# Agenda GOSHEN PLAN COMMISSION Tuesday, December 19, 2023, 4:00 pm Council Chambers, 111 E. Jefferson Street, Goshen, Indiana

To:	Goshen City Plan Commission/Goshen Common Council
From:	Rhonda L. Yoder, Planning & Zoning Administrator
Subject:	23-04R, Rezoning & PUD Preliminary Site Plan Approval 1901 & 1911 S Main Street & 111 River Vista Drive
Date:	December 19, 2023

To:	Goshen City Plan Commission
From:	Rhonda L. Yoder, Planning & Zoning Administrator
Subject:	23-02SUB, Primary Approval, Major Commercial Subdivision Red Oak Subdivision
Date:	December 19, 2023

То:	Goshen City Plan Commission
From:	Rhonda L. Yoder, Planning & Zoning Administrator
Subject:	23-03SUB, Primary Approval, Major Residential Subdivision Double Oak Subdivision
Date:	December 19, 2023

## **RED OAK** PRIMARY SUBDIVISION

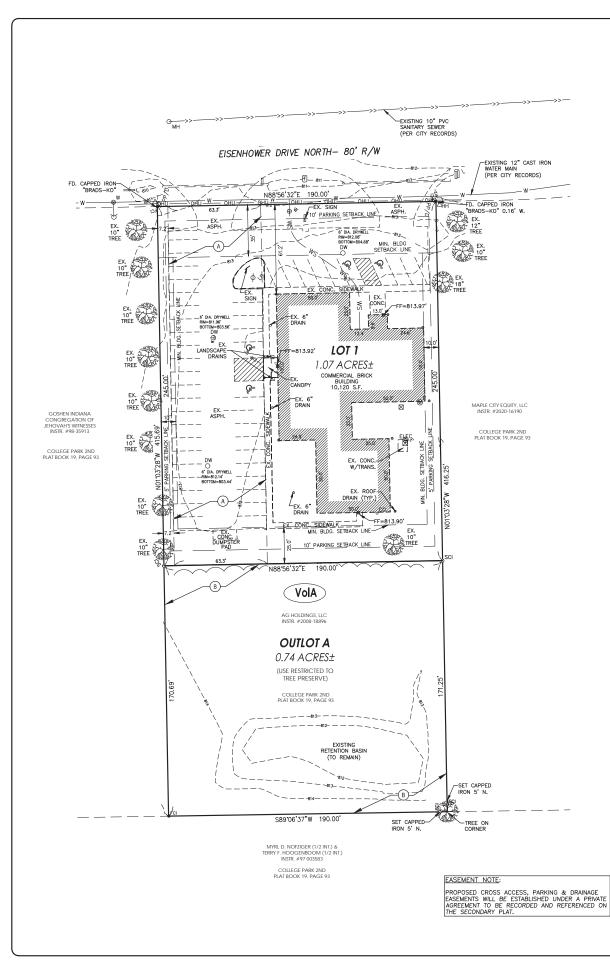
- 1. In the Legend, the reference for easement A should include access, parking and drainage (parking is missing).
- 2. Outlot A requires more detail about the restricted use, including reference to the permanent conservation easement.
